Development Review Board

Tuesday, August 6, 2024, 5:00 PM

ZAP-24-5; 151 Ledge Road (RL, Ward 6) J. Kathleen Tracy

To: Development Review Board
From: Mary O'Neil, AICP, Principal Planner
Date: August 6, 2024
RE: ZAP-24-5; 151 Ledge Road

ELEVATIONS

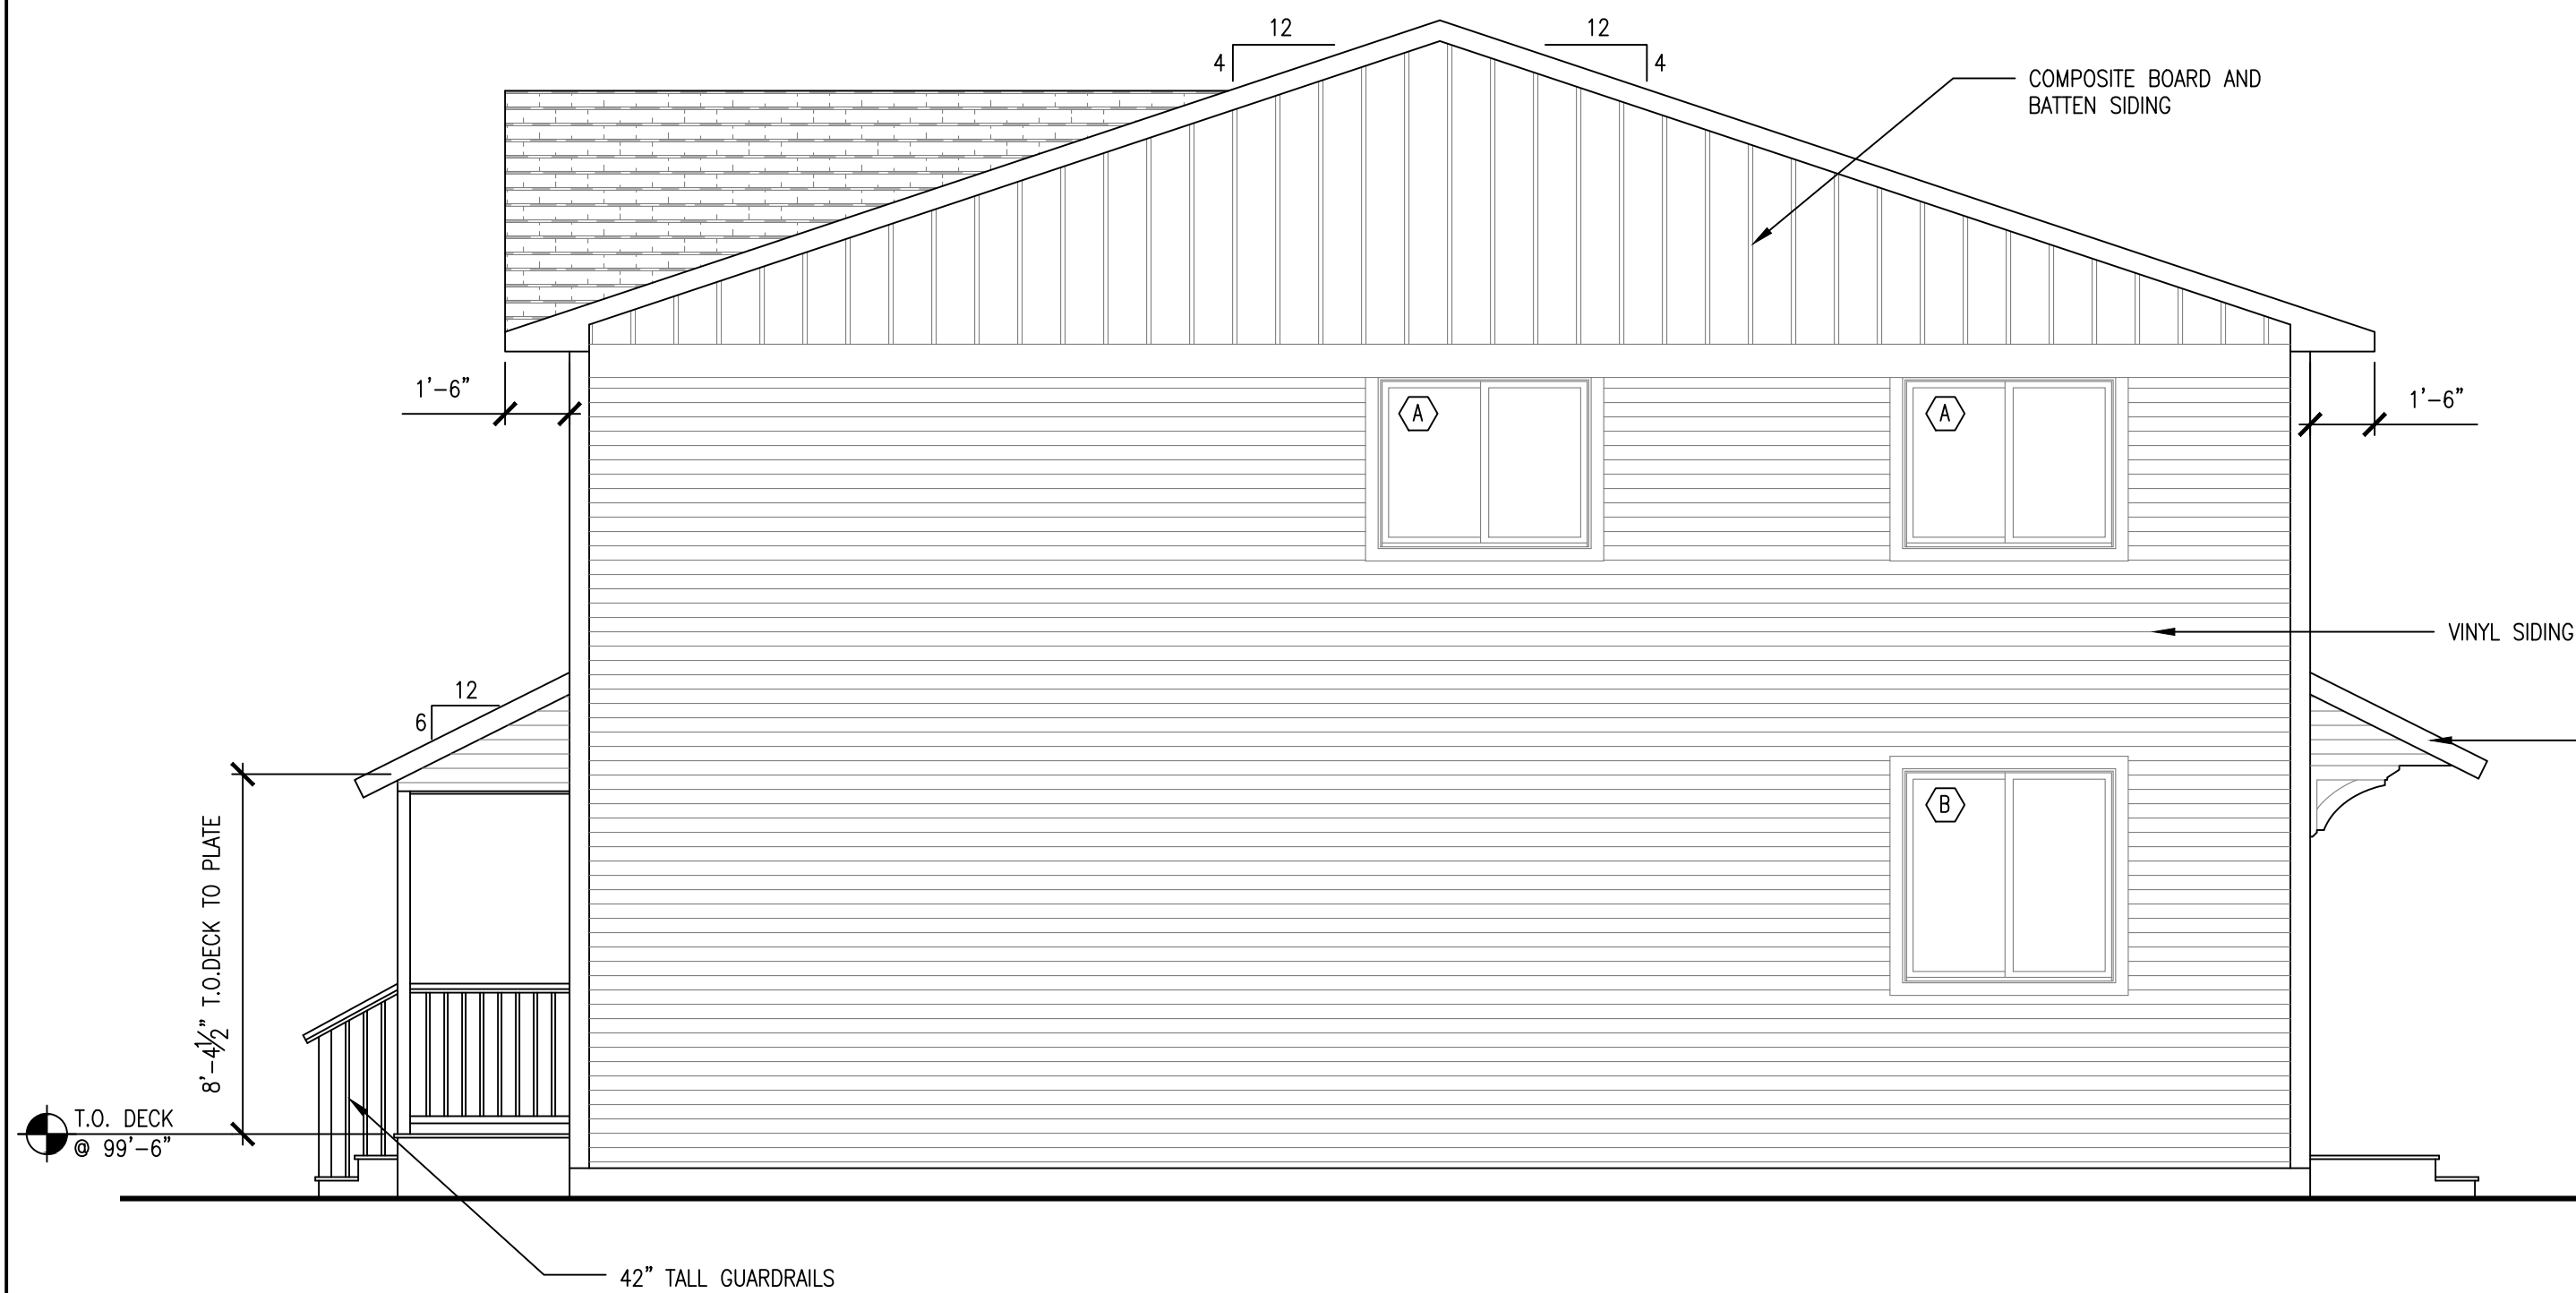
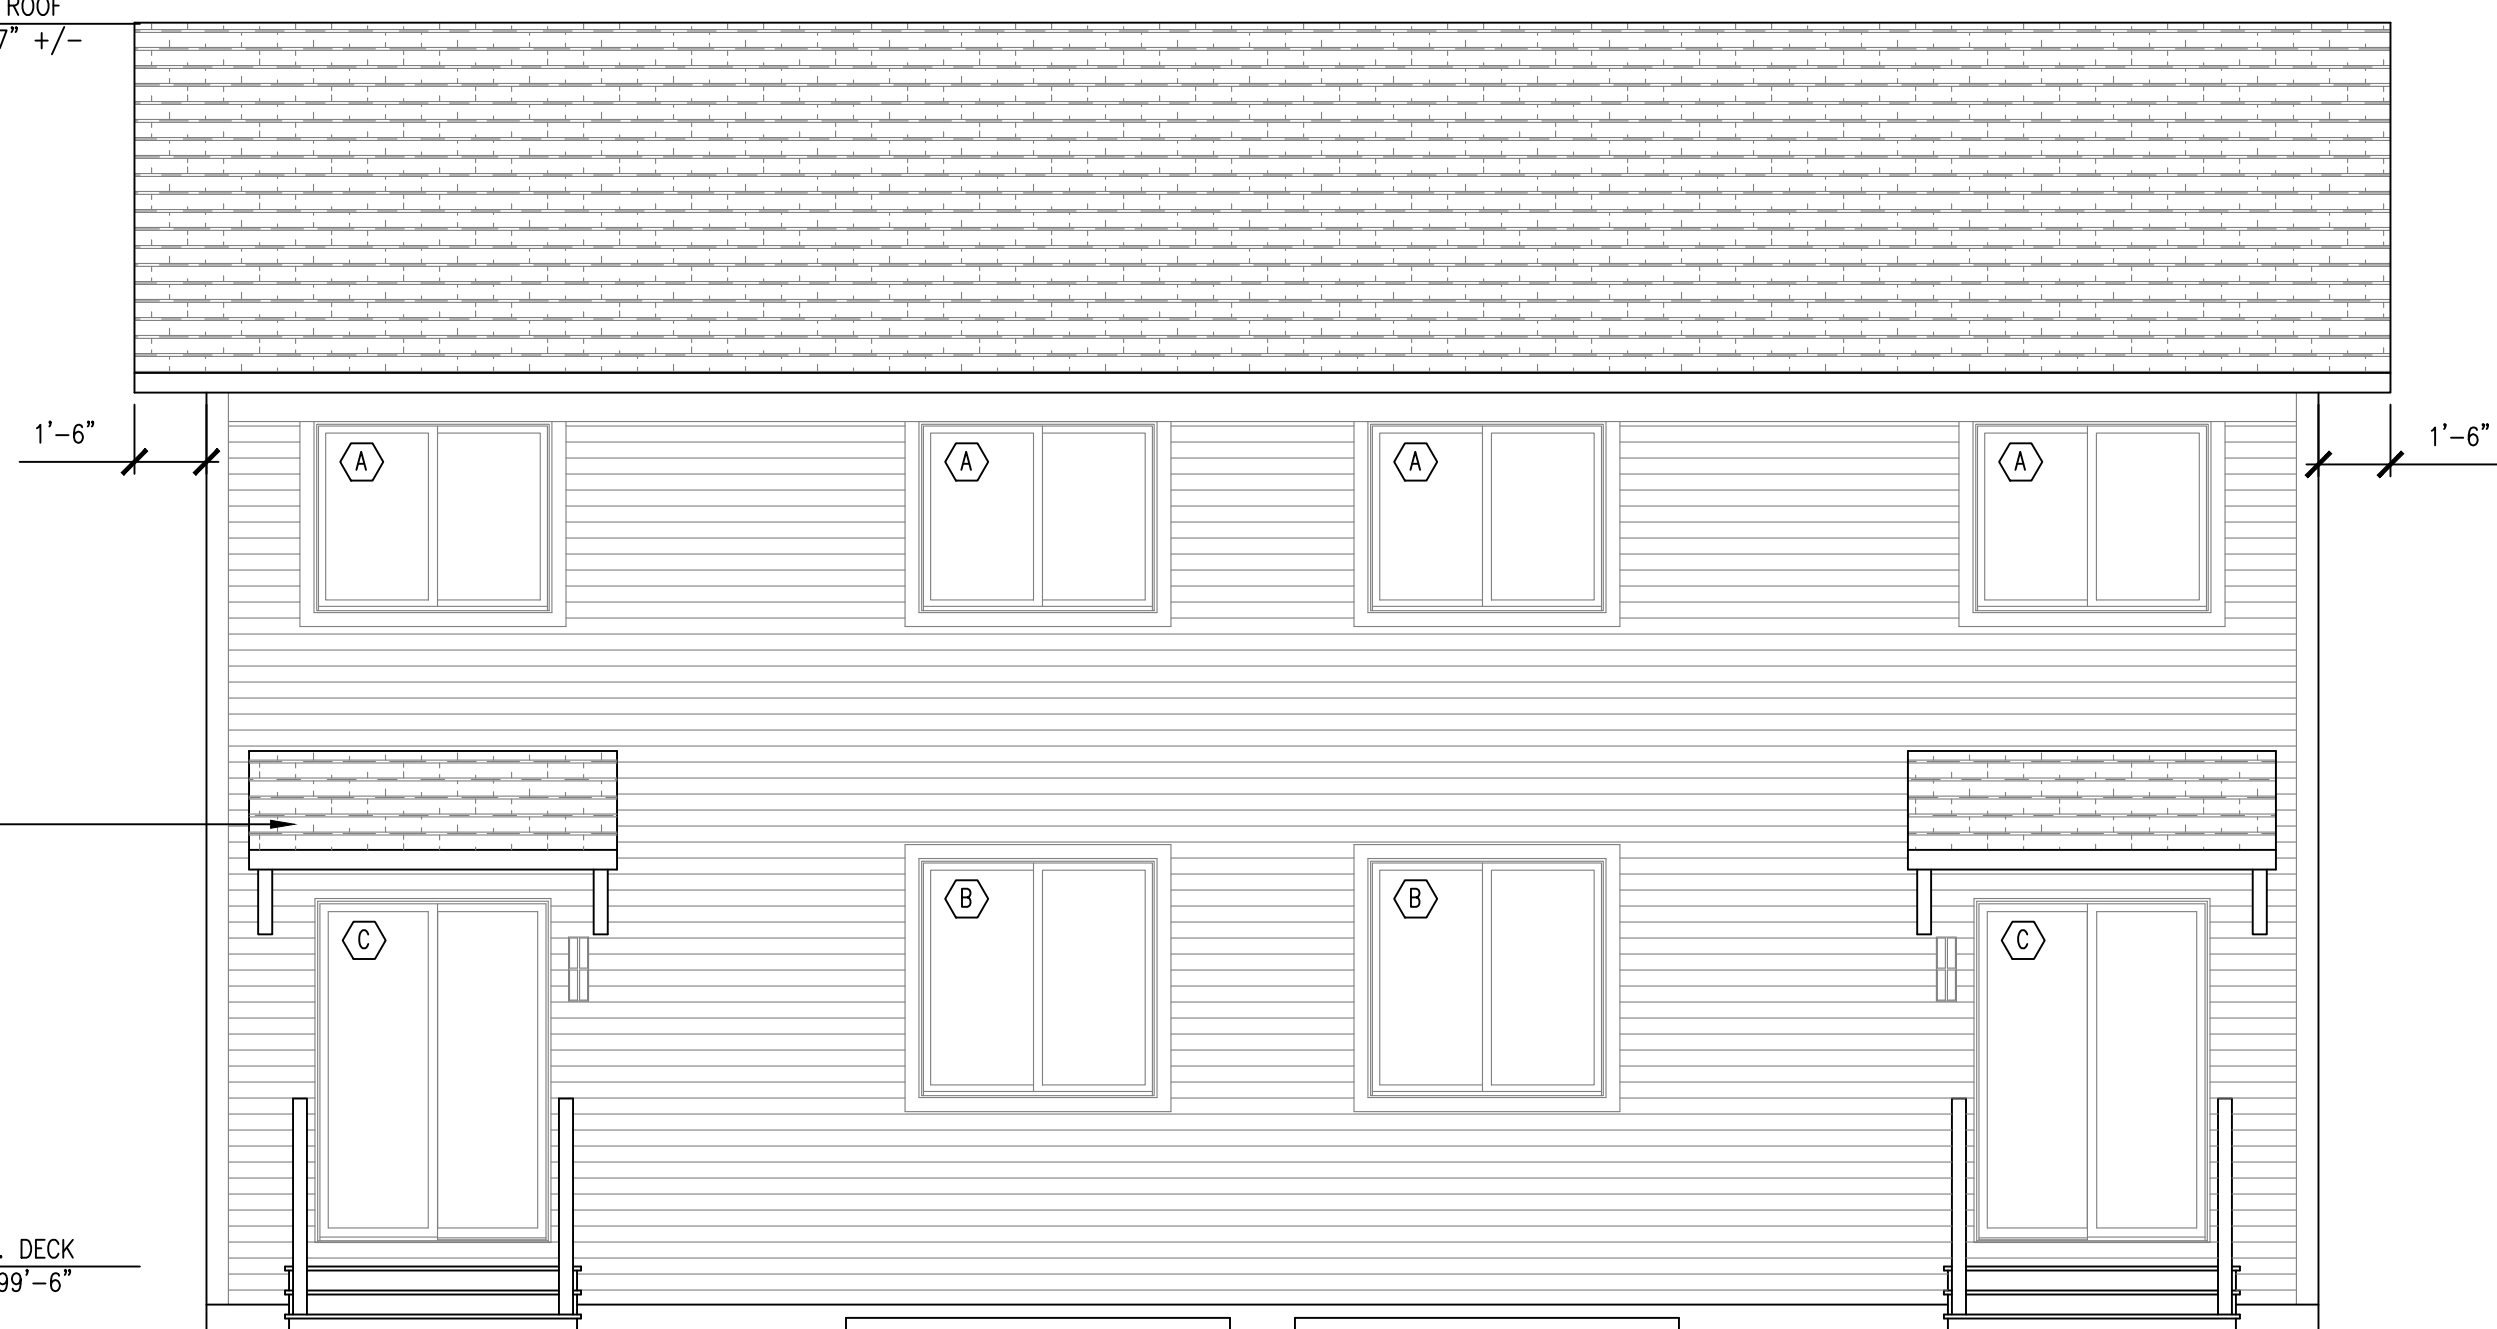
Condensing units are illustrated at the northwest (side) elevation. Mailboxes are adjacent to front entrances. Trash and recycling will be located within the garages. Utility meters are located on a side (northwest) elevation. Reference is made to Plan A2.1. **Affirmative finding.**

Plan A2.1 defines the intention of asphalt shingle roofing, composite board and batten in the gable ends and vinyl siding for the bulk of the structure. All are considered acceptable for new construction.
